DESIGN REVIEW BOARD WORK SESSION

**Design Review Board Case # 20-0001
Block P – 765 John Carlyle**

Block P – DRB Work Session

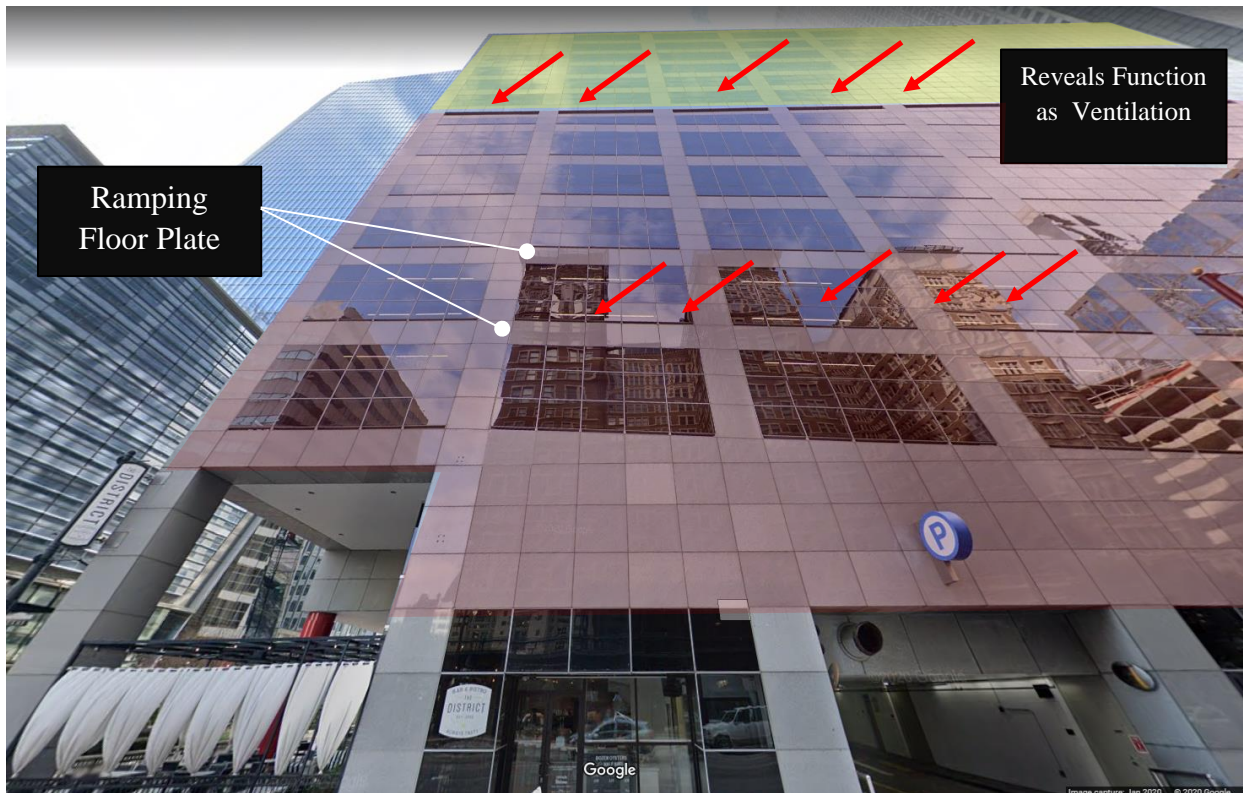
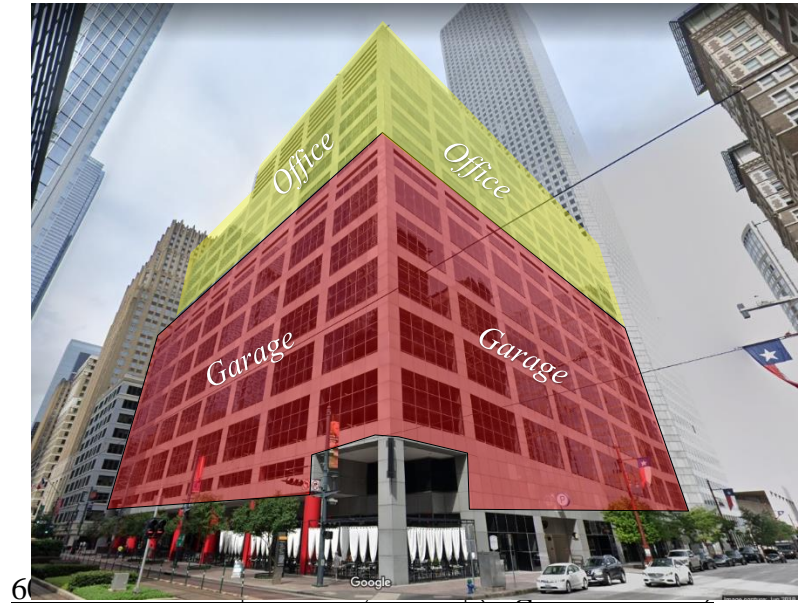
Option #1: One potential technique is to carry some percentage of glazing and other cladding from the occupied levels above, down through the parking skin. More specifically, a narrower glass panels on the north tower, and the ladder-mullioned side panels on the south tower. Examples of this are shown below, the first from the previous approval for this site (“Block P”) and the second from the recently approved and now under construction Previous Design for Block P – Integration of Glazing into Garage Levels (Figure #1 below):

In both of these examples, the garage function is legible, but its presence is suppressed visually through the continuation and integration of high-quality façade elements from the main body of the tower above into the parking level facades.

D. Podium/Base

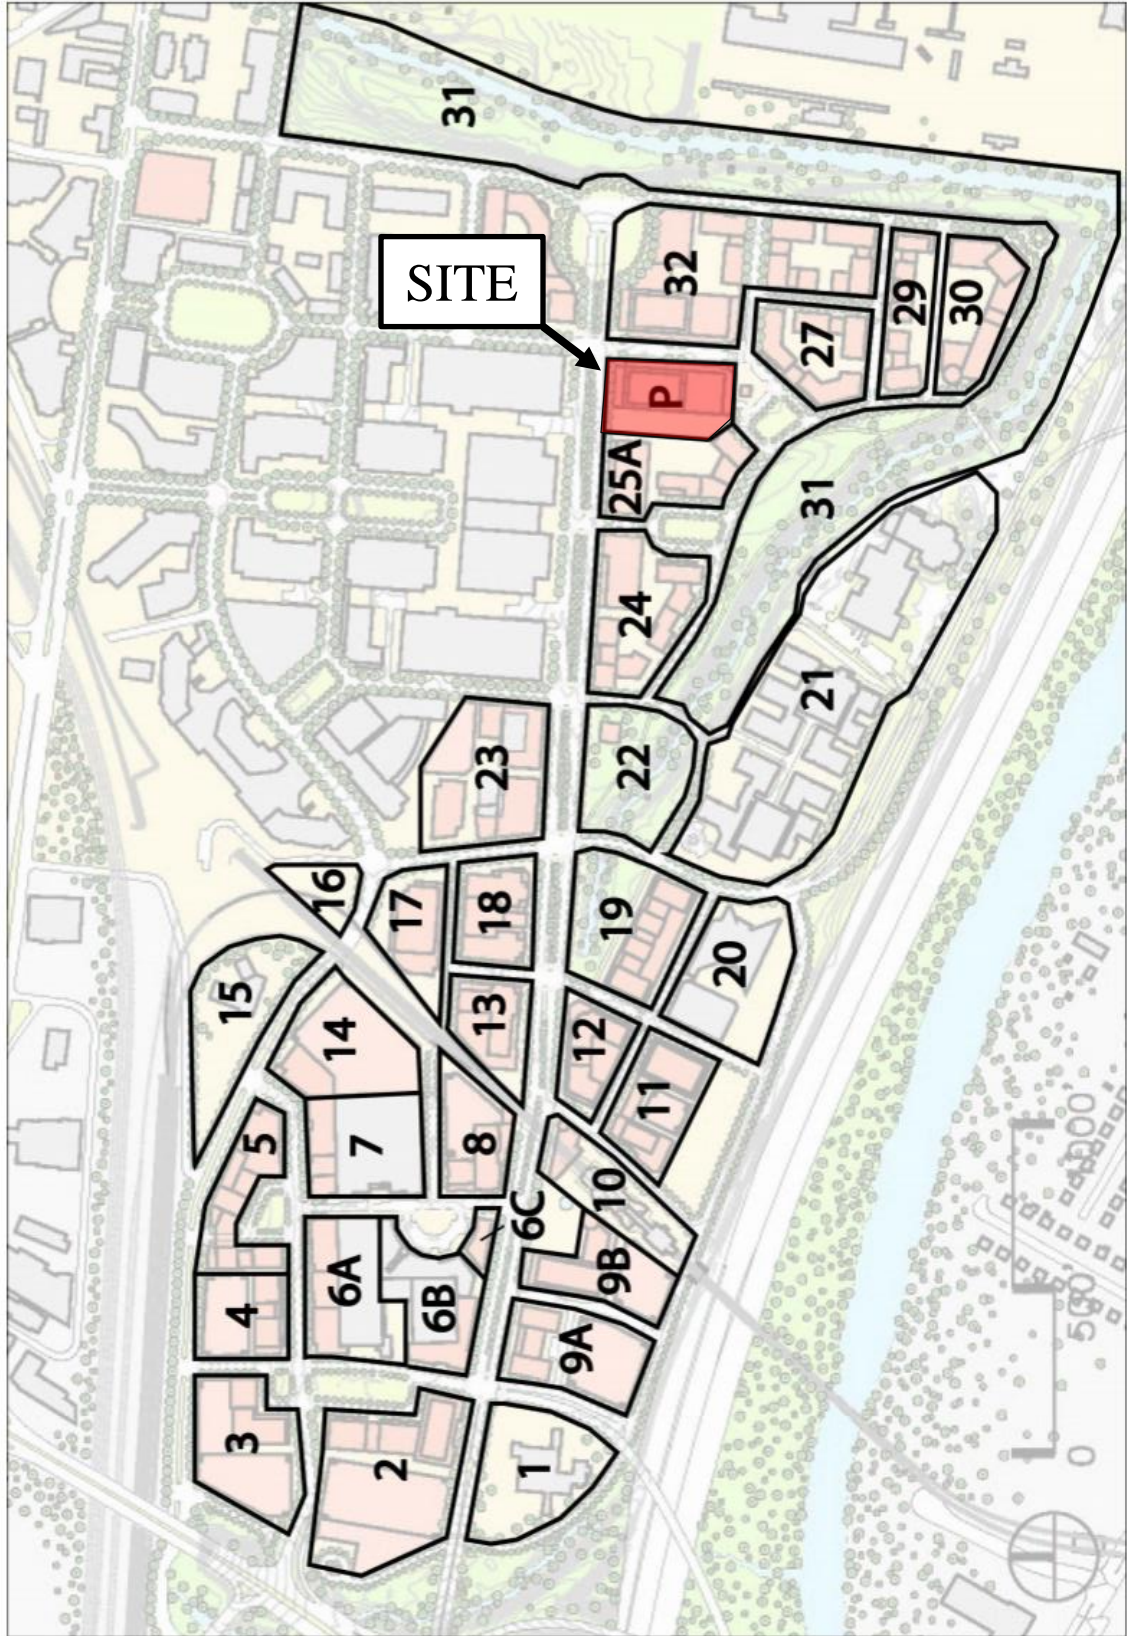
The dark brick frames – apparently superimposed on the south tower base to relate to the lower base datum line on the north tower – detract from the existing strong base of the south. Staff recommends removal of the frames to reinforce the idea of the massing stepping *up*- from north to south. A more successful approach may be to introduce greater richness in brick/masonry detailing to reinforce the design’s verticality.

The more symbolic added base element along the John Carlyle Street frontage of the north tower seems more successful. However, it needs to be better integrated into the other forms and materials of the building behind, see illustration on **Page #13** of the submitted package. This view highlights the challenges of integrating the connector with the two very different architectural languages.

SOUTH PLINTH GARAGE OPENINGS - MATERIAL OPTIONS

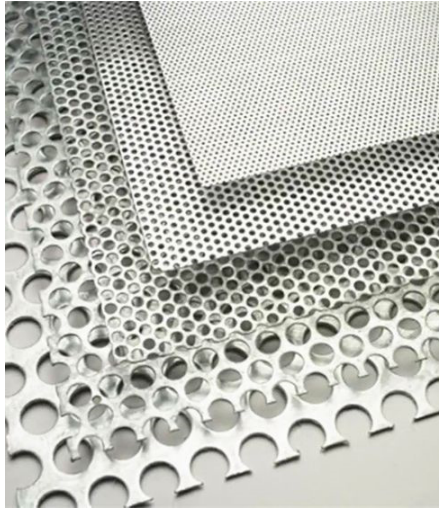
The studies which explore the use of a metal mesh or perforated metal to create screening for the parking are a positive starting point. However, they do not fully disguise that these levels are unoccupied space, and due to this, Staff would like to see a stronger integration of the parking façades into those of the towers above.
